File	Size	Date
O4 Controller	Document Number <Doc>	Thursday, August 12, 2010

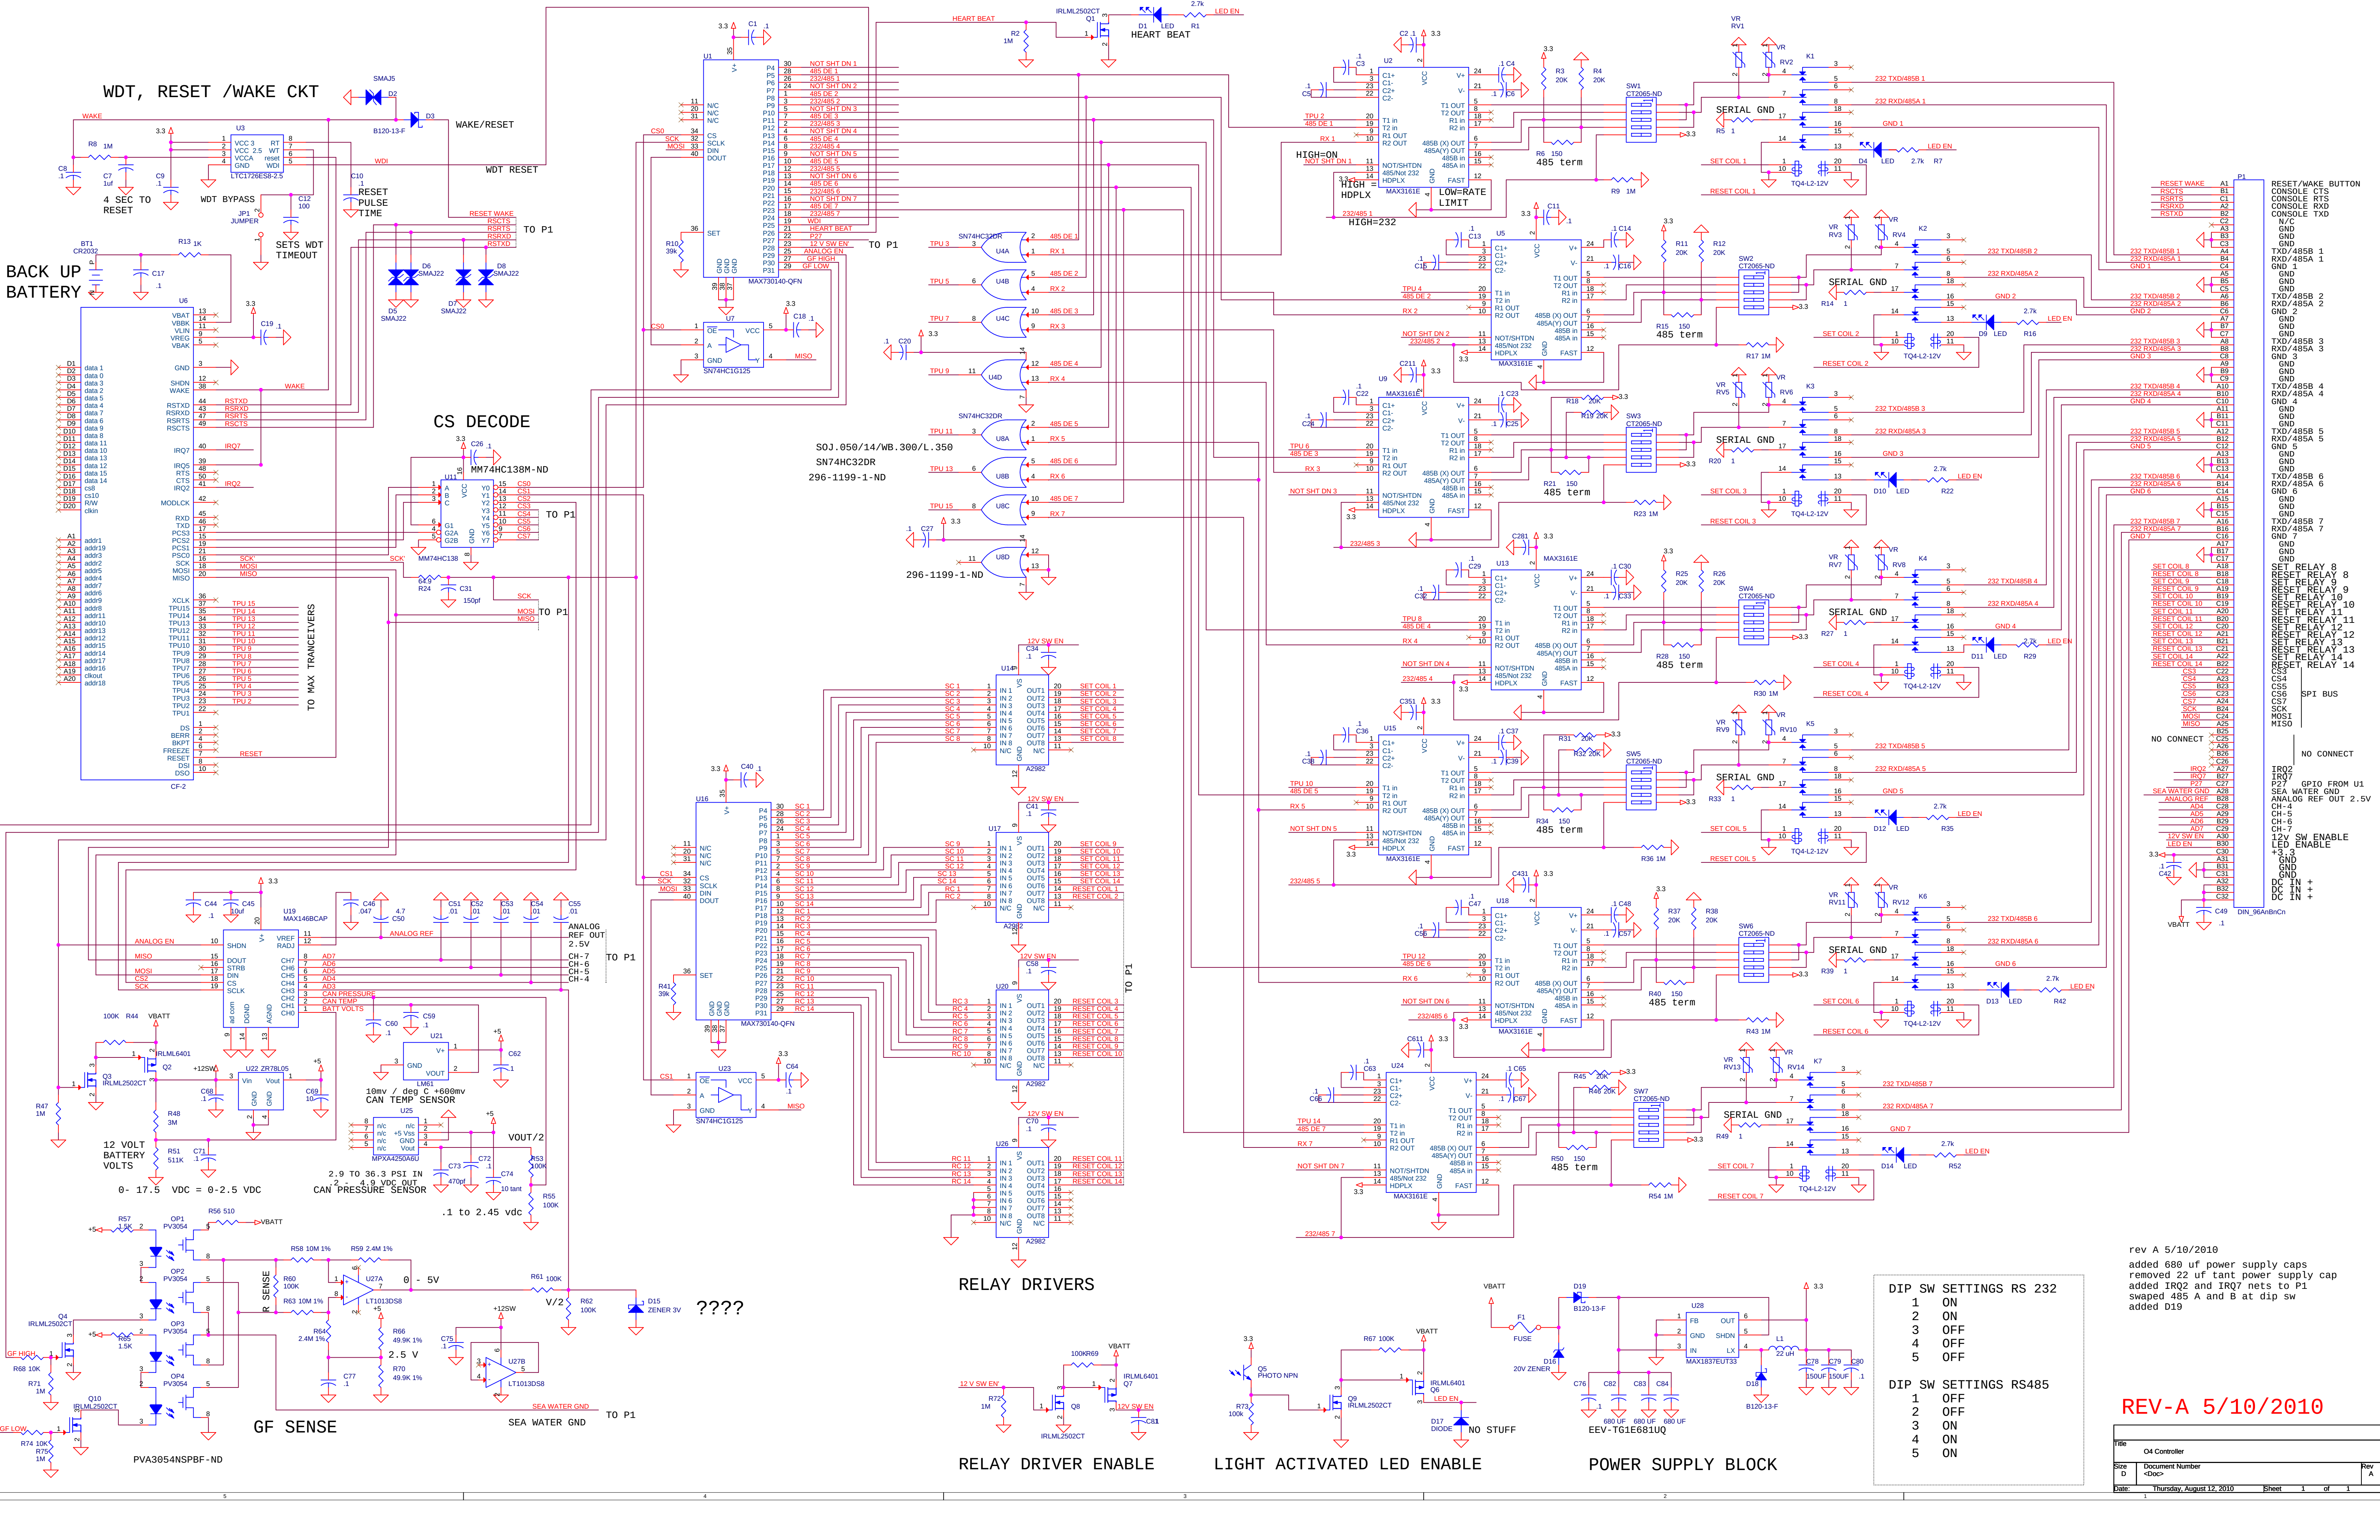
rev A 5/10/2010
added 680 uf power supply caps
removed 22 uf tant power supply cap
added IRQ2 and IRQ7 nets to P1
swapped 485 A and B at dip sw
added D19
